4.0 PLANNING CONSULTATION

4.0 PLANNING CONSULTATION

4.0 PLANNING CONSULTATION

Fig. 6 PRE-APP - SITE LAYOUT & STREET ELEVATION

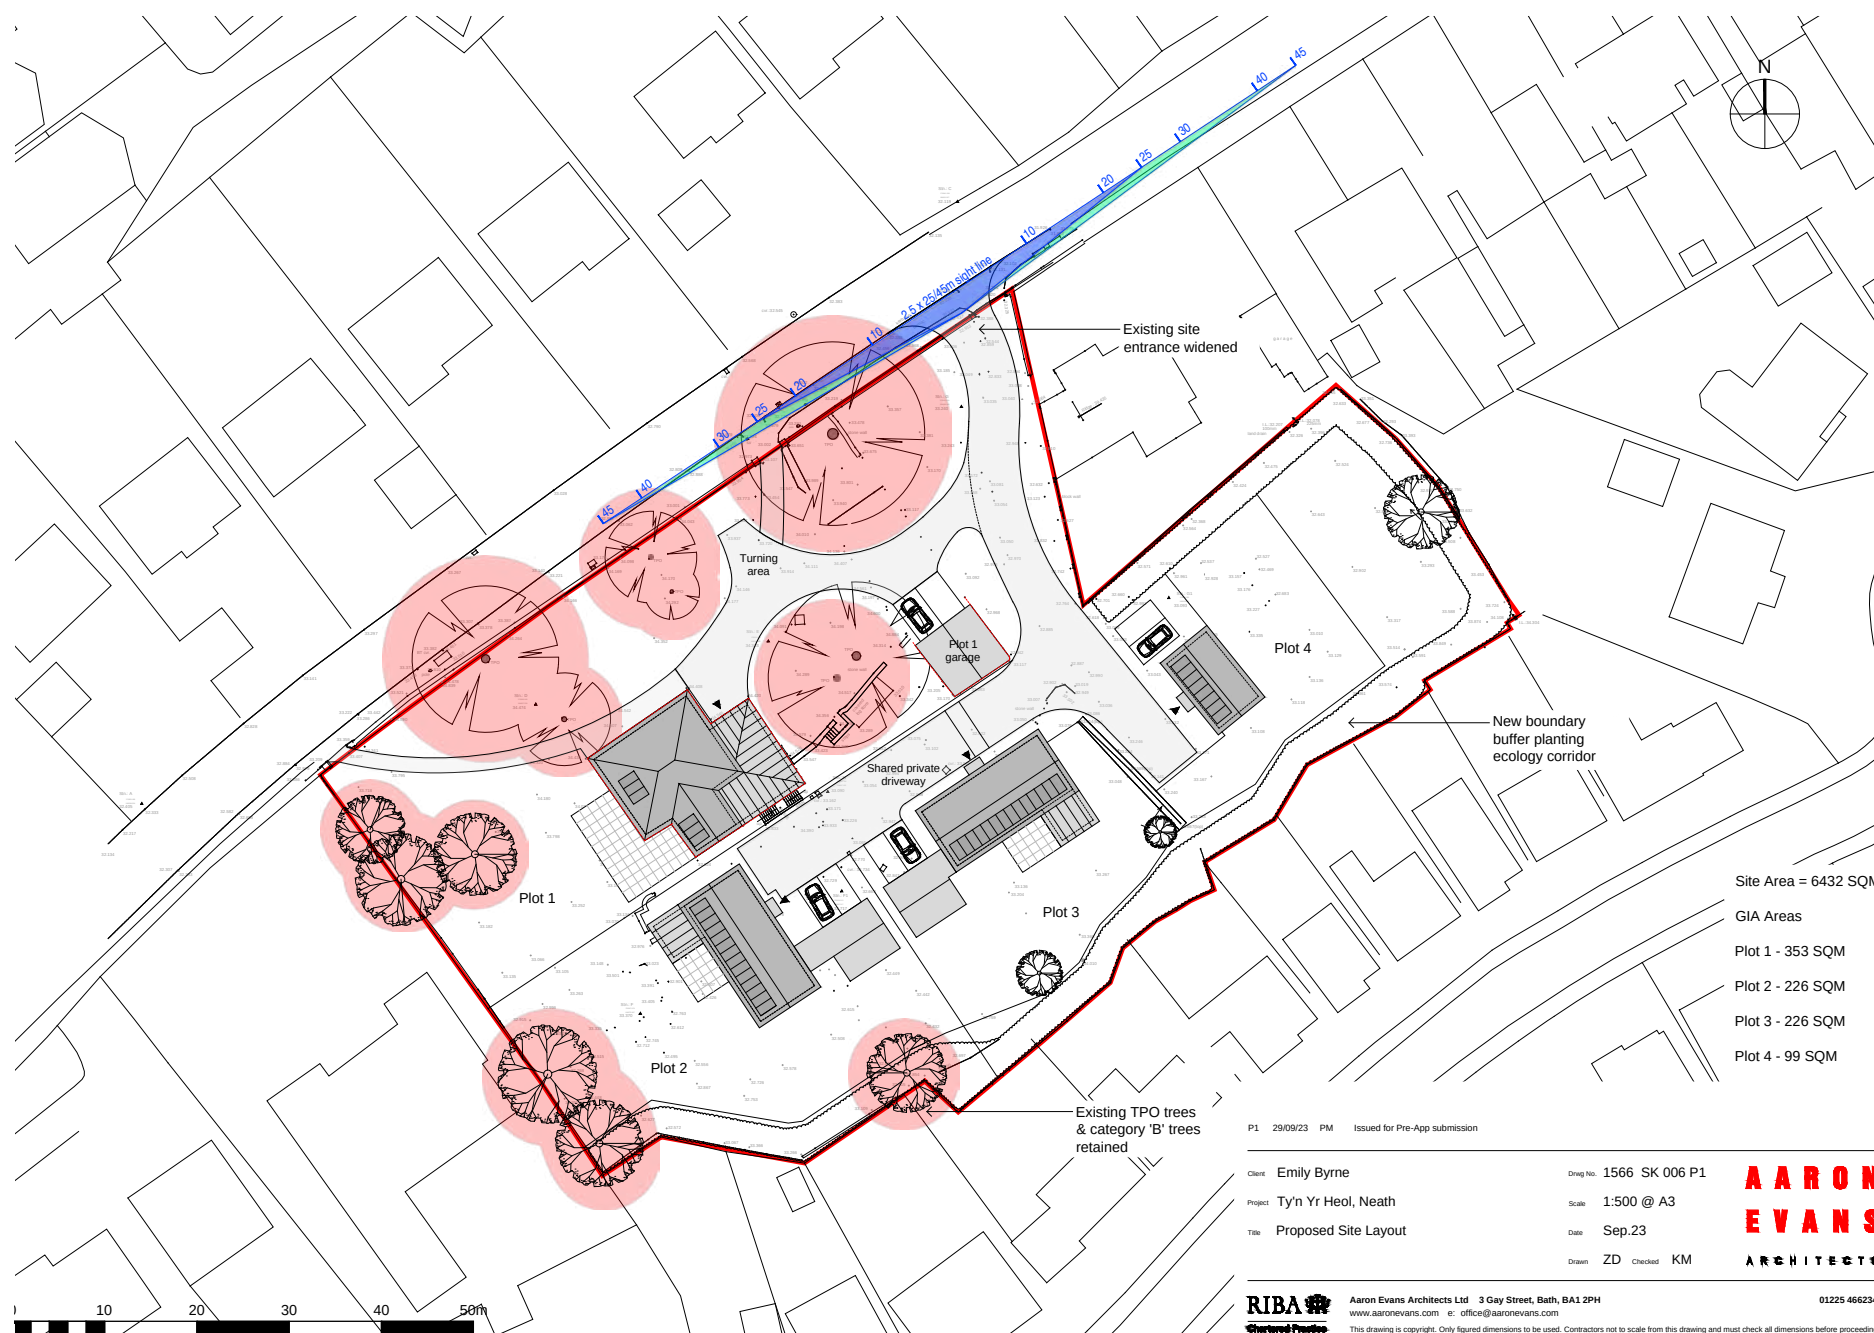
'While consideration is given to the context and constraints of the site, noting the TPOs and principles of development centred on the historic layout of the site, concerns are raised within regard to the proposed density and the ineffective use of land.'

The layout submitted was *'not considered to result in an unacceptable overbearing or overlooking impact upon neighbouring properties'*. It was noted that levels and window positions would need to be determined, including the relationship between plots 1 and 2.

- A shared drive was not considered acceptable. A new access road built to highway authority standards (min 5.5m width with 2m footways) with adequate turning facility should be provided.
- Vehicular vision splays should be in accordance with TAN 18.
- 'Parking spaces' / driveways and should be a minimum of 6m long and 3.6m wide for a single driveway, 6m x 6.2m for double side by side parking. Minimum garage sizes were also advised. Notwithstanding the above it was acknowledged that the current Parking Standards SPG only requires spaces to be at least 4.8m x 2.6m.
- Parking standards are 'maximum' standards and shall be provided at a rate of 1 space per bedroom up to 3 spaces.
- A pedestrian crossing point to be provided at the new access point.
- A street lighting scheme shall be submitted.
- SAB approval would be required prior to any work commencing.
